Product Change Notification

PCN #:1-2018

DATE: 03/20/2018

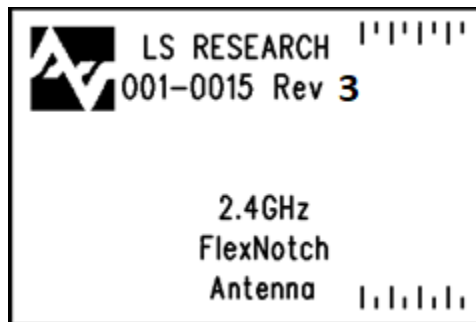
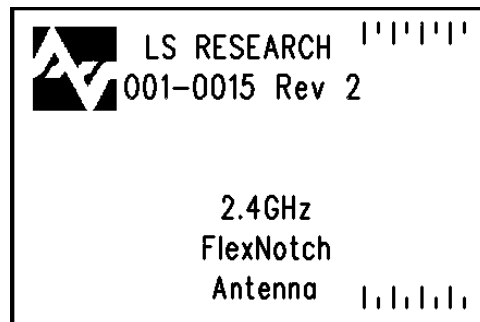
Old Material

New Material

- Color Variation due to Material Change (Copper different color)
- Silkscreen change to reflect new Revision

- Antenna Color Change

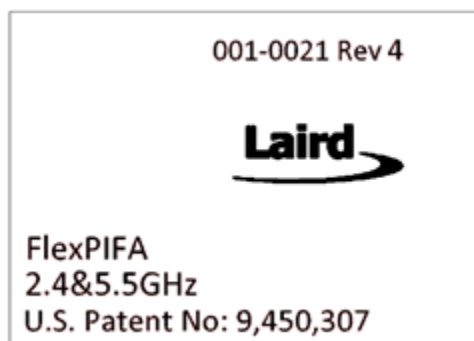
- 001-0014

- 001-0015

- 001-0016

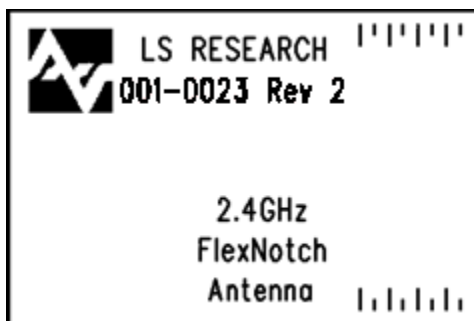
- 001-0021 Rev 3
- Laird**
- FlexPIFA
2.4&5.5GHz
U.S. Patent No: 9,450,307

- Laird**
- 001-0022 Rev 2
- 2.4GHz FlexPIFA
- U.S. Patent No: 9,450,307

- LS RESEARCH
001-0023 Rev 1
- 2.4GHz
FlexNotch
Antenna

- Antennas with the new revision as currently shipping.
